# Staff Summary Report

Development Review Commission Date: 05/24/2011

**SUBJECT:** Hold a public meeting for a Development Plan Review for LAKE COUNTRY VILLAGE PHASE ONE, located at 1030 East Baseline Road.

**DPR11057** – Development Plan Review including site plan, building elevations, and landscape plan.

Phase I Enlarged Site Plan  
 04-05-11  
 10116-ST07

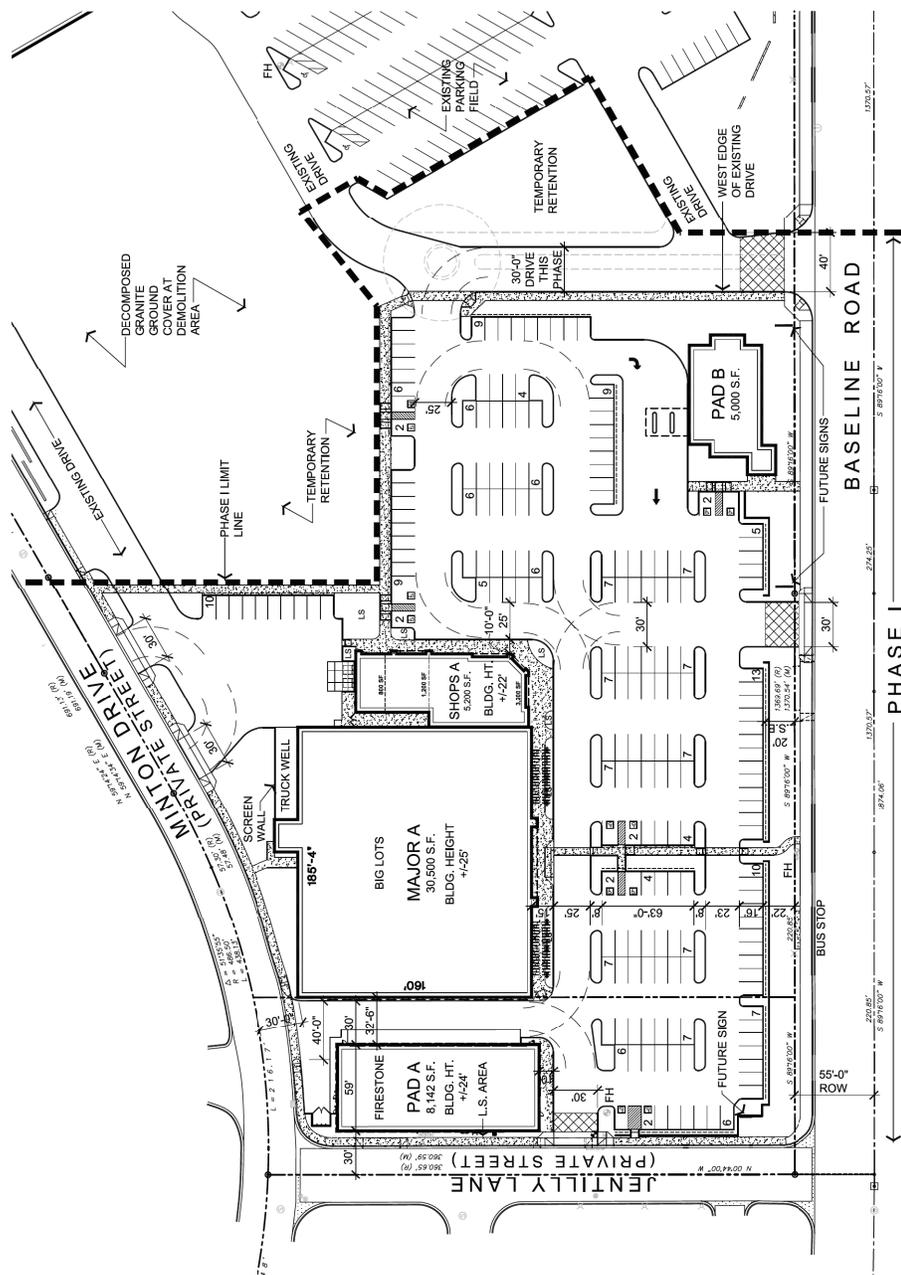
4. In Phase One, reduce provided vehicle surface parking quantity to conform to the maximum allowed parking total for the total building area indicated in Phase One OR obtain a Use Permit to allow provided vehicle surface parking in excess of 125% of required parking quantity. To maintain the proposed total building area in Phase One and avoid the Use Permit requirement, utilize the following methods. Add cart corrals with landscape planting areas flanking the corrals. Increase the amount of disabled accessible parking adjacent to business entrances.

5. In Phase One, provide bicycle parking spaces in the following minimum quantity and locations. Three (3) in paved portion of landscape area northeast of Shops 'A' building. Two (2) on each side of Major 'A' entrance, or four (4) total. One (1) near Pad 'A' building entrance. Two (2) near Pad 'B' building entrance.

7. Move Pad 'A' building and service courtyard screen wall minimum 3'-0" to the south to create a minimum 3'-0" wide planting strip between the Minton Drive walkway and the screen wall AND remove the screen wall from the Pad 'A' driveway sight visibility triangle on Minton.

8. Provide a 3'-0" high masonry wall along Minton Drive to visually screen the parking spaces northeast of Shops 'A' and the broad paved truck maneuvering area north of Shops 'A'. Provide 3'-0" high masonry screen wall at parking along Jentilly Lane as indicated. Provide a minimum 6'-0" high masonry courtyard screen wall and refuse enclosure wall along Minton Drive and Jentilly Lane to the north and northwest of Pad 'A' except reduce the wall height from 6'-0" to 3'-0" at the easternmost 20'-0" length, adjacent to the driveway. Do not locate screen walls within the sight visibility triangles of adjacent driveways or at the intersection of Jentilly and Minton.

SOUTH ELEVATION MAJOR A & SHOPS A

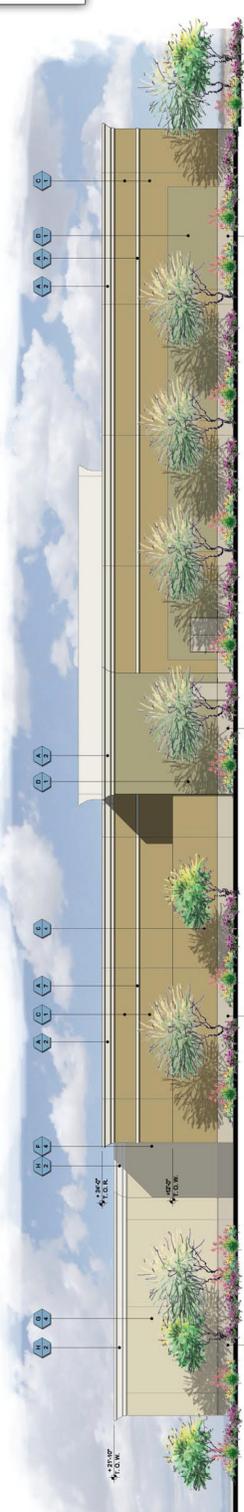
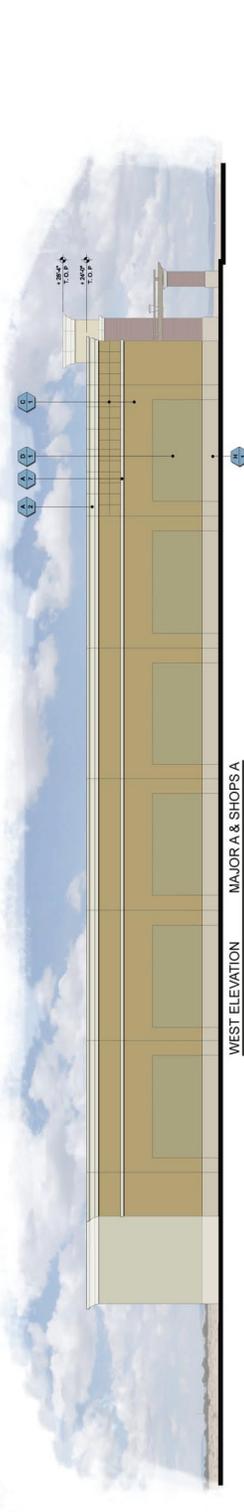
16. At the upper walls of Major 'A', extend the horizontal formed plaster band around the three exterior walls of the receiving room on the north side of the building.

17. At the upper walls of Major 'A', extend the pattern of tool joinery indicated on the south elevation between the horizontal formed plaster band and the top of the building around the other building elevations. This grid of tool joinery may be interrupted at the raised parapet of the main entrance (as indicated) and at Shops 'A'.

18. The materials and colors are approved as presented on the Lake Country Village materials sample board, dated May, 2, 2011. Provide main colors and materials with a light reflectance value of 75 percent or less. Specific paint colors, red brick veneer, red barrel tile, black canvas awning and dark bronze anodized aluminum that are exhibited on the materials sample board are approved. Submit any additions or modifications for review during building plan check process. Major modifications will require separate Development Plan Review by the Development Review Commission.
